UNITED STATES PATENT AND TRADEMARK OFFICE

APPLICATION NO.	FILING DATE	FIRST NAMED INVENTOR	ATTORNEY DOCKET NO.	CONFIRMATION NO.
10/630,443	07/30/2003	Jerry E. Bandstra	2-5169-049	9315

Office Action Summary	Application No.	Applicant(s)	
	10/630,443	BANDSTRA ET AL.	
	Examiner	Art Unit	
	Árpád Fábrián Kovács	3671

DETAILED ACTION

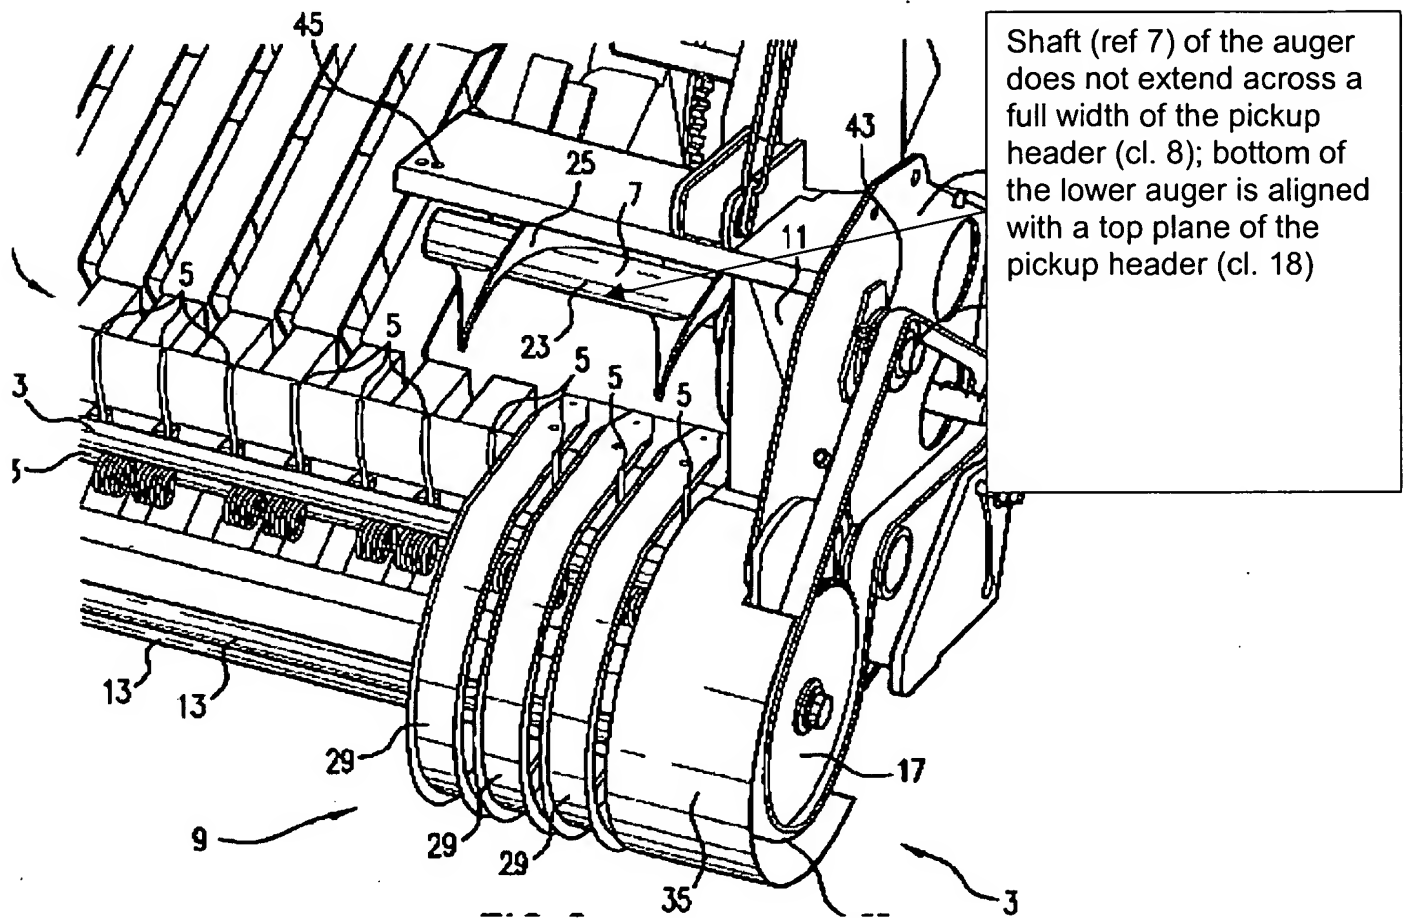
In re claim 8. An apparatus for crop processing having a processing width defined by a distance between a left side and a right side of a processing unit, the apparatus comprising:

a pickup header that is wider than said processing width (see marked up figure below);

an auger on at least one of a right side and a left side of the

pickup header to move crop material laterally (see marked up fig below).

McClure discloses the claimed invention except for duplicating the right or left augers as claimed.

It would have been obvious to one having ordinary skill in the art at the time the invention was made to have at least 2 augers on top of each other, since it has been held that mere duplication of the essential parts of a device involves only routine skill in the art. *St. Regis Paper Co. v. Bemis Co.*, 193 USPQ 8.

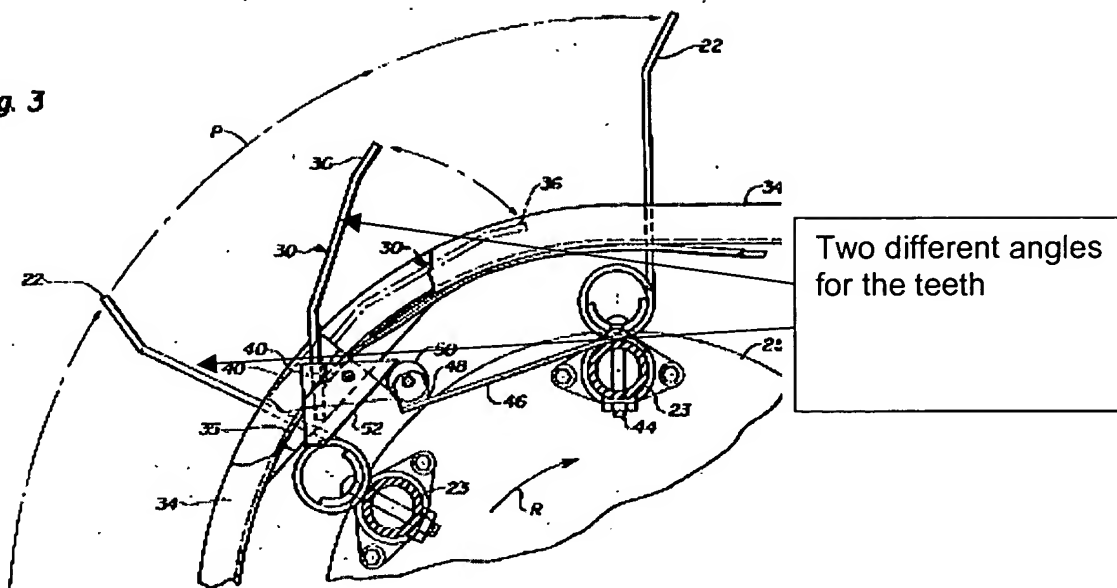
McClure does not provide for rotational speed of the auger as claimed.

In Grahl: as shown in fig 2, pair of augers on at least one of a right & left sides of the pickup header (4 augers are shown, two on each side), which are driven at different rotational speeds (the upper & lower are driven at different speeds; see fig 5, the sprockets are of different size, and their driven in different rotational direction, for these 2 reasons the speeds are different).

It would have been obvious to one having ordinary skill in the art at the time the invention was made to utilize for the duplicate (pair of) augers of McClure different rotational speed as taught by Grahl, in order to increase efficiency.
